Commercial Technical Service Department—Service Bulletin

Issue: New Vitamix single item number motor replaces 4 different item numbers.

Subject: 120 volt Motor (Drink Machine, 2 Speed, Drink Machine Advance, T&G)

Replacement Item Number: 062467 (Universal Motor Assembly)

Figure 1

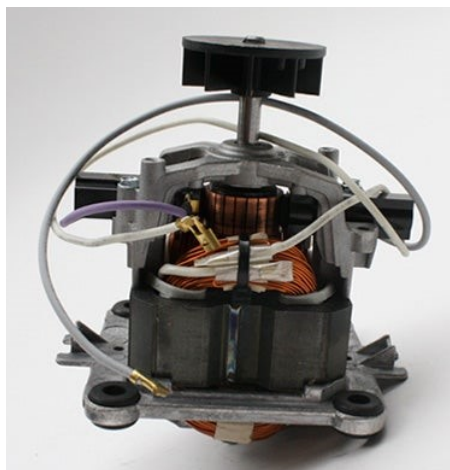
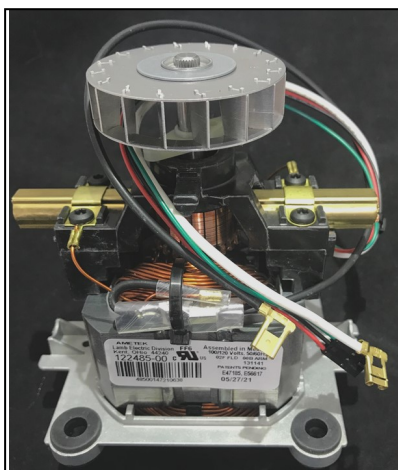
We are replacing the following motor kits 015669,015672,015679,015680 these kits are for the motor shown (see Figure 1) in this bulletin.

These motor kits will be replaced with Vitamix kit 062467 (see Figure 2.) Figure 2 motor will have the following differences. The new motor will have a metal fan , and brass brush holders,. It will have the thermal cut out (thermocouple) enclosed to prevent damage. The new motor will have white and black motor wires . Please attach the white wire as you did on the current motor, and attach the black wire in the same location you attached the gray wire on the current motor your are removing.

Figure 3

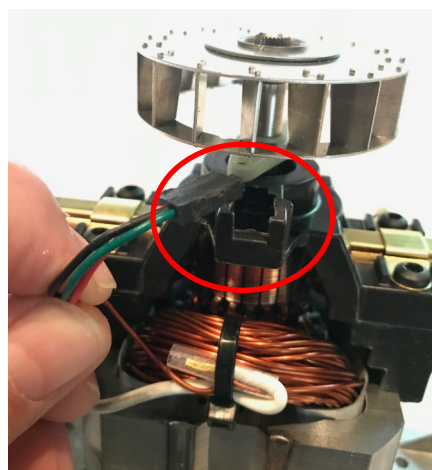
The new motor will have a “Hall effect” speed sensor installed. If you are repairing a blender that does not require this sensor you can easily remove it, by holding the wires, and pulling to physically remove it from its mounting (see Figure 3) If you have blender that requires the Hall effect speed sensor it will plug right in to the control board. We will be updating our exploded view and price list to reflect this change. Please update your records, and web page as necessary.
